DESIG	DESIGN DRAWN BY		DART AEROSPACE LTD HAWKESBURY, ONTARIO, CANADA	
CHEC	KED	APPROVED	DRAWING NO.	REV. A
(	LE	dt	DSI 9377	SHEET 1 OF 2
DATE			TITLE	SCALE
07.0	07.05.24		STRUT MODIFICATION KIT	NTS
Α		07.05.24	NEW ISSUE

## DART SERVICE INSTRUCTION

TO AMEND INSTALLATION INSTRUCTIONS IIN-D130-701 REV. B REF. CANADIAN STC: SH94-14 REF. FAA STC: SR00213NY

## **DETAIL A: STRUT INSTALLATION**

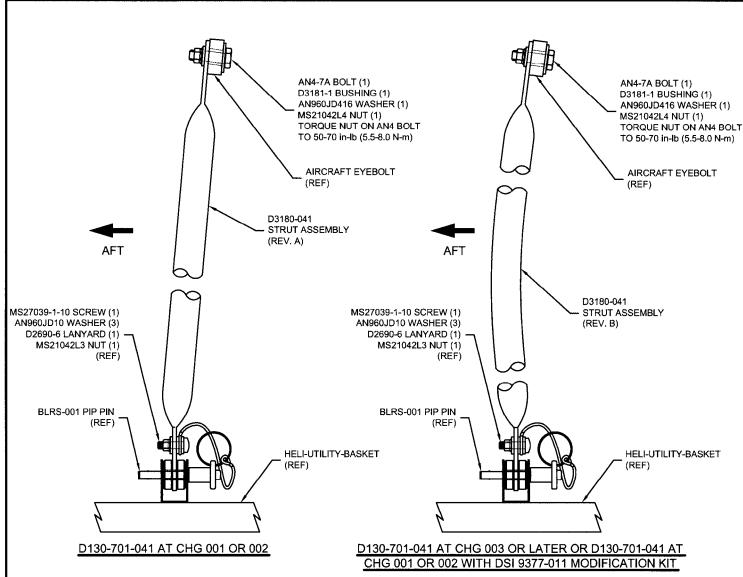
TO MAKE THE D130-701-041 HELI-UTILITY-BASKET COMPATIBLE WITH THE EUROCOPTER CANADA CARGO PODS, THE D3180-041 STRUT ASSEMBLY HAS BEEN MODIFIED AS SHOWN IN DETAIL A IN D130-701-041 AT CHG 003 OR LATER. TO MAKE THE DART D130-701-041 HELI-UTILITY-BASKET AT EXISTING CHG 002 OR EARLIER COMPATIBLE WITH THE CARGO PODS, IT IS NECESSARY TO REPLACE THE D3180-041 STRUT ASSEMBLY WITH THE DSI 9377-011 STRUT MODIFICATION KIT. THIS KIT INCLUDES A REPLACEMENT STRUT AND THE HARDWARE REQUIRED TO INSTALL IT.
